## MCHD Series

### Appearance Change Notification

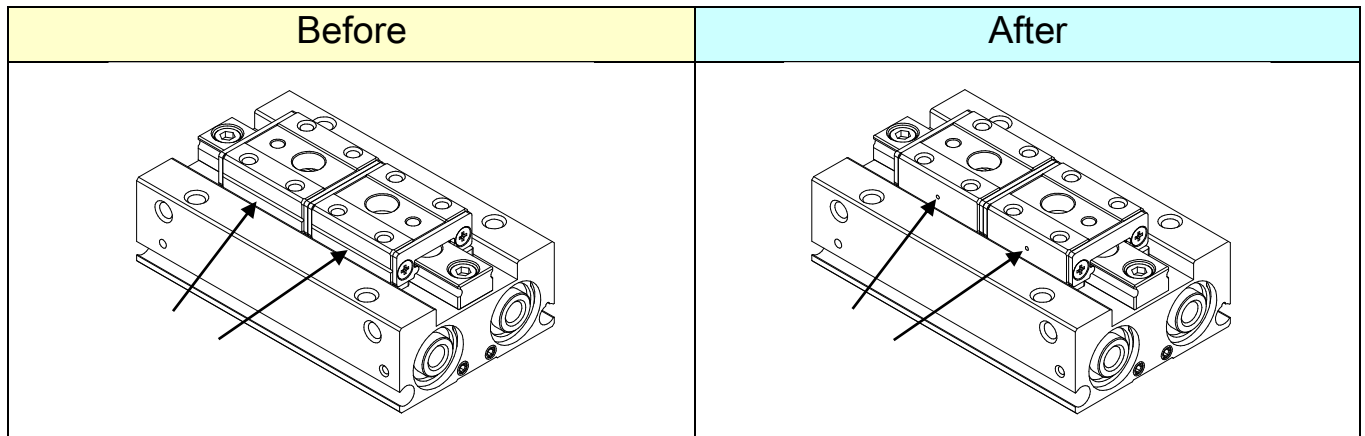
1. Model series  
MCHD-Ø8~Ø20
2. Design change reason  
Optimize appearance.
3. Change descriptions
